L-2011-416
10 CFR 52.3

September 30, 2011

Re: Florida Power & Light Company
Proposed Turkey Point Units 6 and 7
Docket Nos. 52-040 and 52-041
Second Response to NRC Request for Additional Information Letter No. 035
(eRAI 5681) Standard Review Plan Section 13.03 – Emergency Planning

Figure I-1
Environmental Survey Team Map Turkey Point Nuclear Power Plant – 10 Mile EPZ

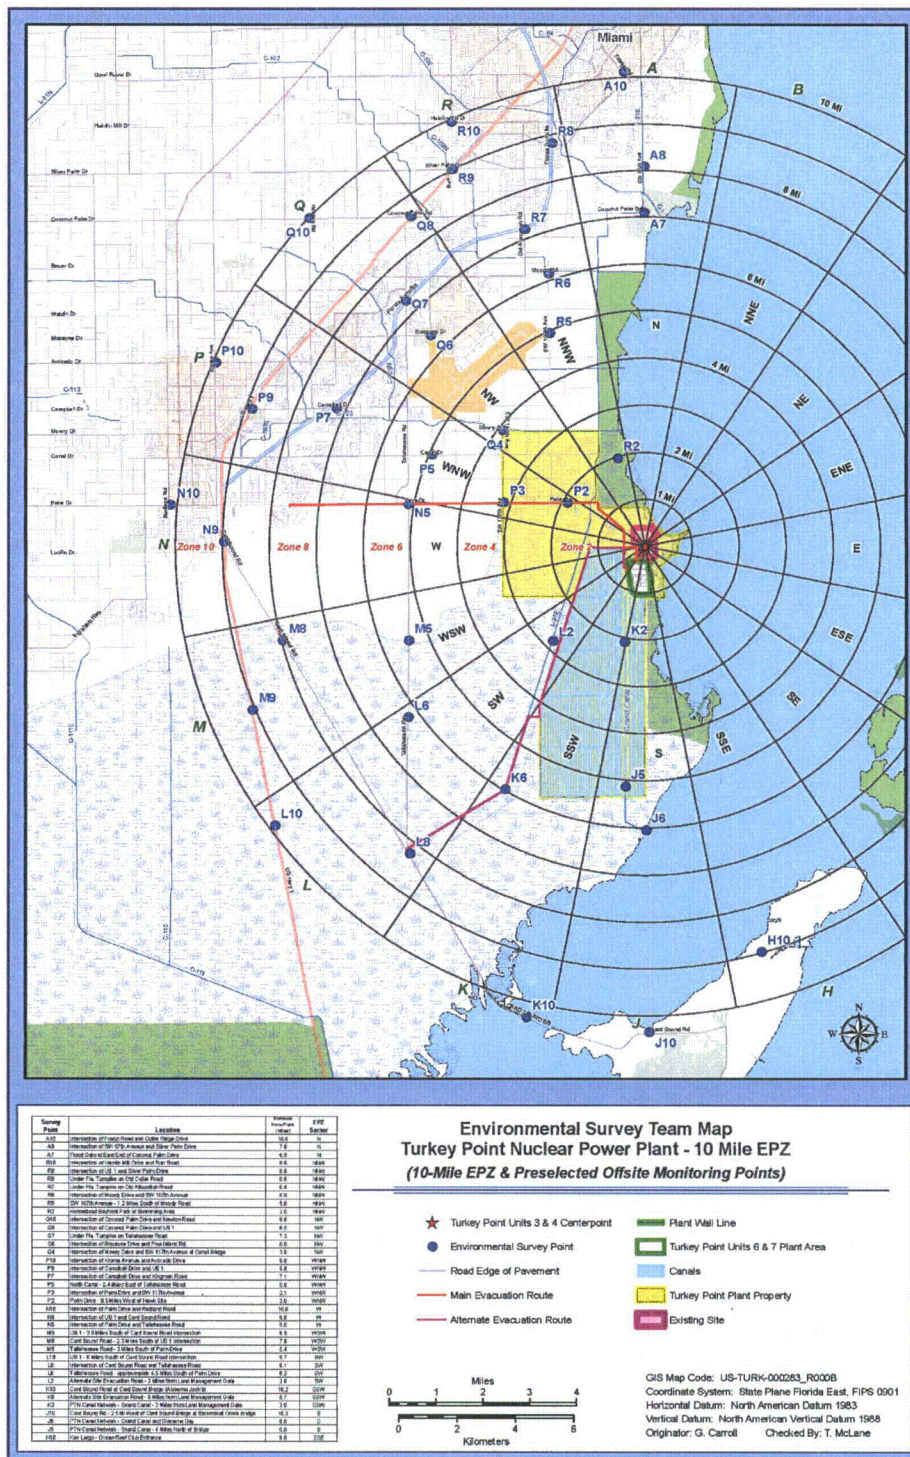
Provide a map in the Emergency Plan that shows the pre-selected radiological sampling and monitoring points. The map should include the designators in NUREG-0654 Table J-1, or an equivalent uniform system described in the Emergency Plan.

FPL has enhanced the Units 3 & 4 field monitoring team map with pre-determined radiological sampling and monitoring points, as illustrated in Figure I-1. The map provides designators similar to those in Table J-1 of NUREG-0654. The map will be incorporated into a future revision of the Emergency Plan.

In a future COLA revision, the Emergency Plan will incorporate into Section I.8 Figure I-1, as shown below:
